Subdivision Authority

File No. LDA06-0248

RE: Tentative plan of subdivision to create two medium density residential lots, one commercial lot, and one public utility lot from portions of SW-8-52-23-4 and NW-8-52-23-4 located south of Whitemud Drive and east of 17 Street SW; **TAMARACK**

SUBDIVISION CONDITIONS OF APPROVAL MAP

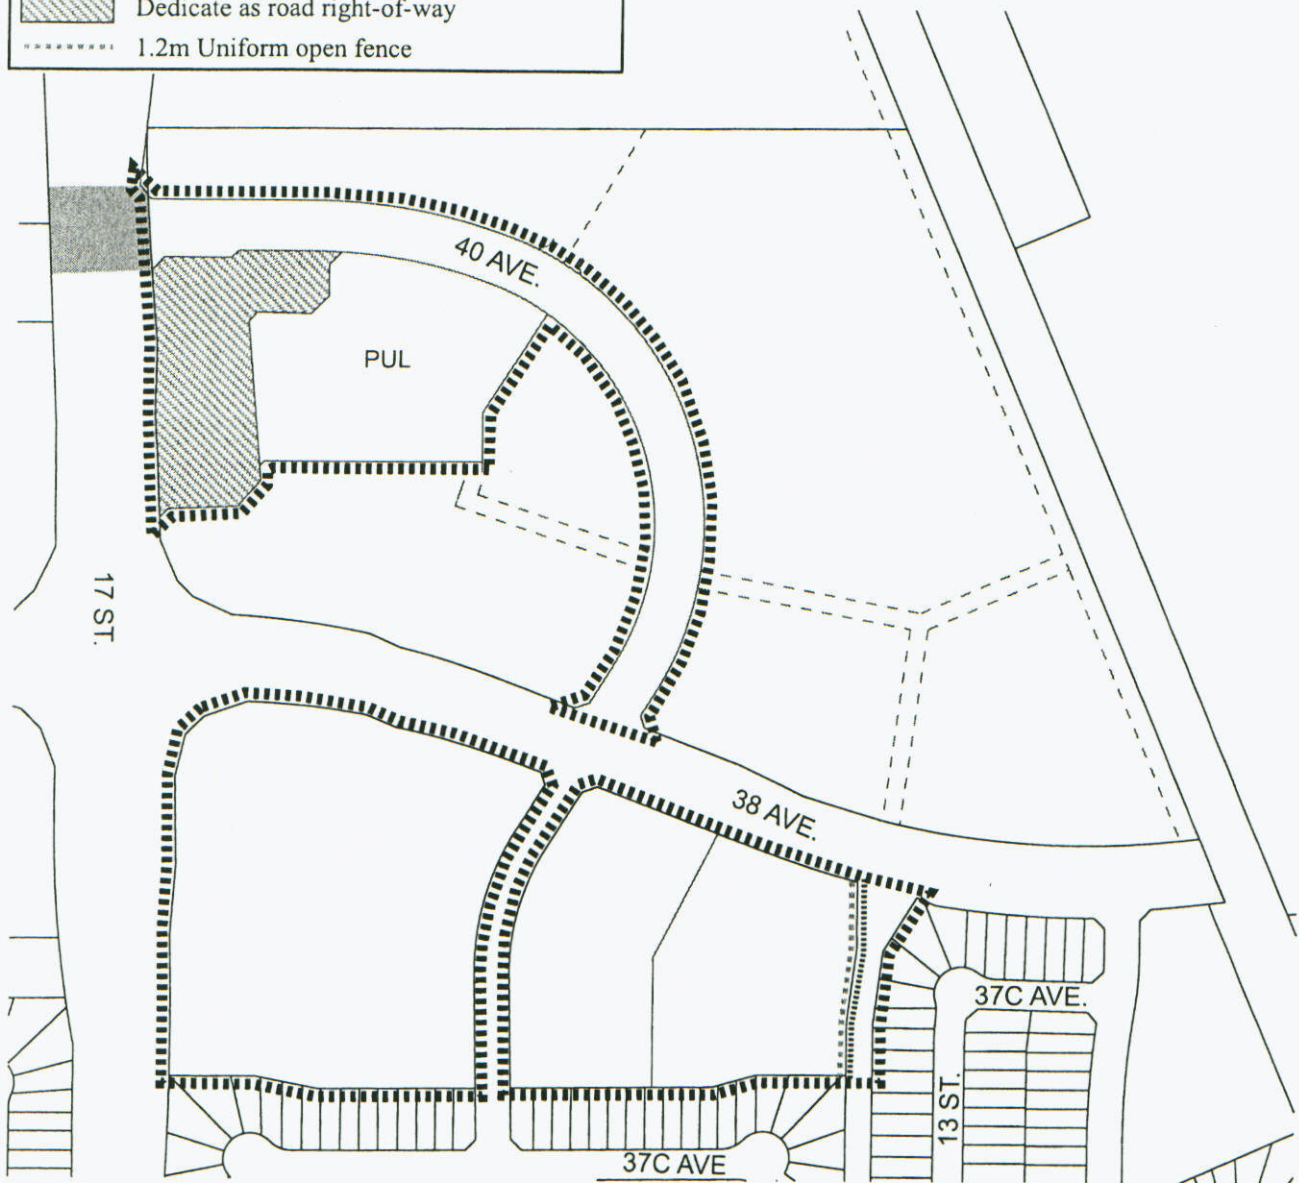
3. that the subdivision boundary be amended to exclude the north/south walkway east of the MDR site as shown on the "Conditions of Approval" map, Enclosure I;

6. that the engineering drawings include connection to the existing 350 mm water main at the intersection of 17 Street and 40 Avenue as shown on the "Conditions of Approval" map, Enclosure I;

10. that the owner construct all fences positioned wholly on privately-owned lands to the satisfaction of the Asset Management and Public Works Department in the location as shown on the "Conditions of Approval" map, Enclosure I; and
